STAFF REPORT: 07/08/2020 MEETING

APPLICATION NUMBER: 20-6771

ADDRESS: 1411 IROQUOIS

SCOPE: DEMOLISH REAR WINGS AND REPLACE WITH A NEW WING AT SAME LOCATION

PROPOSED REAR ELEVATION

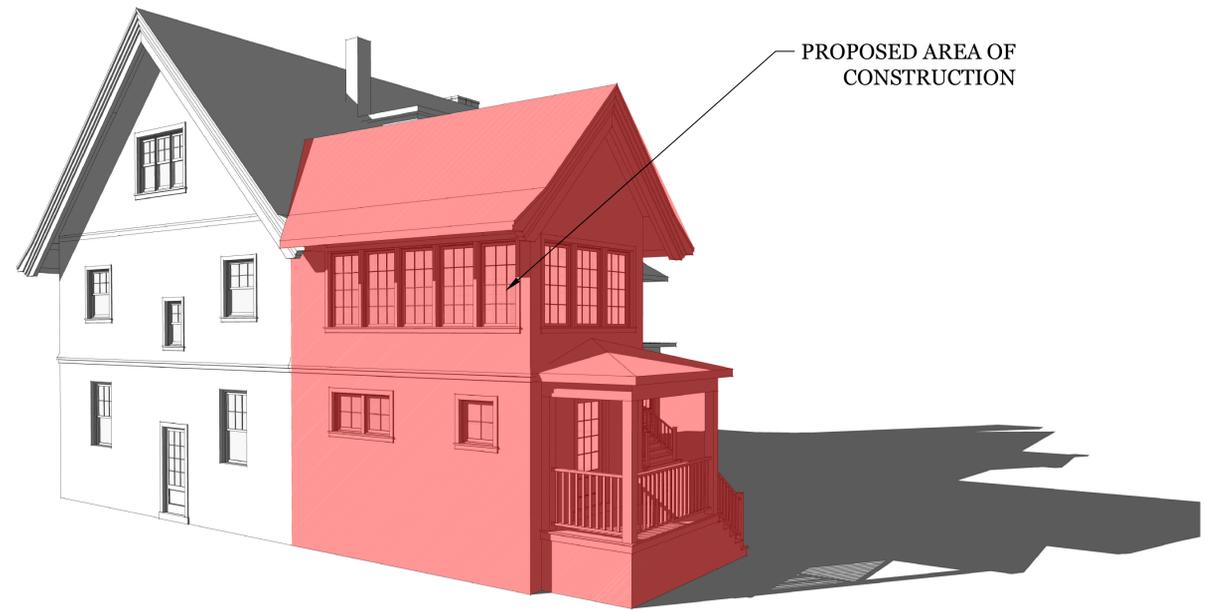
With the current proposal, the applicant is seeking the Commission's approval to demolish the rear two-story projecting wing in its entirety and replace it with a new two-story, gabled-roof wing which shall be clad with brick at the first story and stucco at the second story. As per the submitted drawings, the windows will be wood, aluminum-clad, double-hung, fixed, and casement units. Grids/muntins will be simulated divided lite/will be affixed to the exterior surface of the glass. A hipped-roof entry porch with a brick base and steps will shelter a single, multiple lite door. Note

that the drawings indicate that the door will be fiberglass while the shop drawings state that the door will be wood.
